STAFF REPORT: PERMIT AMENDMENT

APPLICATION NO: A-4-STB-93-154-A-2

APPLICANT: Arco Oil and Gas Company (Agent: R. Whitt Hollis)

DESCRIPTION OF AMENDMENT: Modify a number of existing elements of the golf course including layout of fairways putting greens and driving range, tees, cart paths, vehicular entrances, location of storage lake, architectural design of buildings, drainage design, future horse tie-up/bicycle rack; change the location and number of bridges; add a pump house, and a six-acre parcel to the project site; add a concrete terminus to the vertical access west of Tomate Canyon; and revise the project description to reflect proposed changes and to conform to previously included elements in design plans.

PROPOSED REVISED ARCO GOLF COURSE PLAN

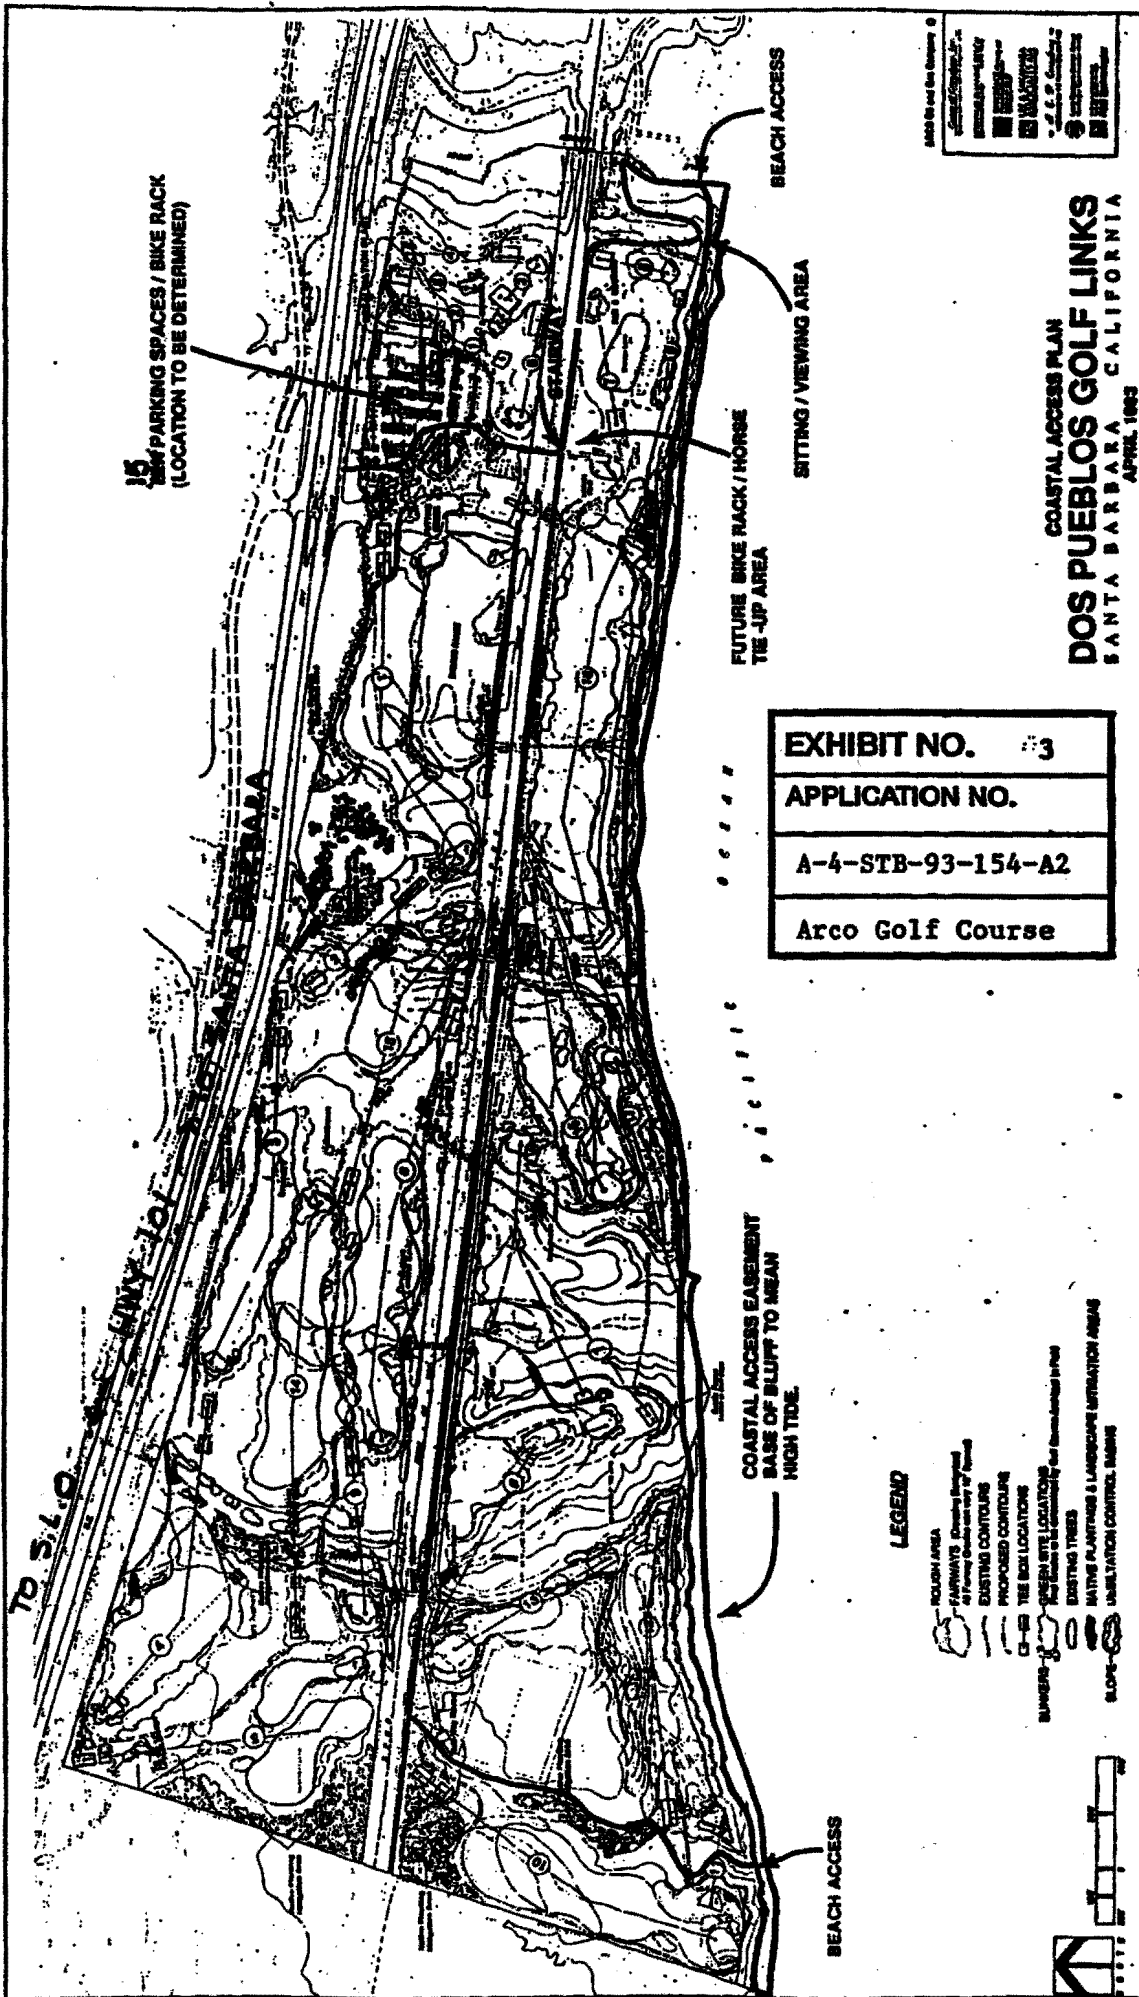
1. **Modification of water storage lake.**

The water storage lake will be relocated to the east of the location previously approved and the shape modified to avoid impacting the newly emerged wetlands to the west and south of the lake, as well as the archaeological site to the east. Additionally, the original estimated volume of the lake has been changed from 4 to 5 acre-feet to 5.4-acre feet due to a minor change in the depth of the lake.

The shape of the driving range has been modified at the west end, the middle driving range tee area has been removed the back driving range tee area has been enlarged, and the front driving range tee area has been reduced. The modification of the west end was designed to avoid a small seasonal wetland area in Drainage #3. The removal of the middle driving range tee area eliminates the need to fill a drainage swale, which will now be left in its natural condition.

- Hole #16 – modification of fairway to avoid 0.5869 acre wetlands 100 foot buffer; addition of back tees for better playability
- Hole #17 – minor adjustment of tee box locations
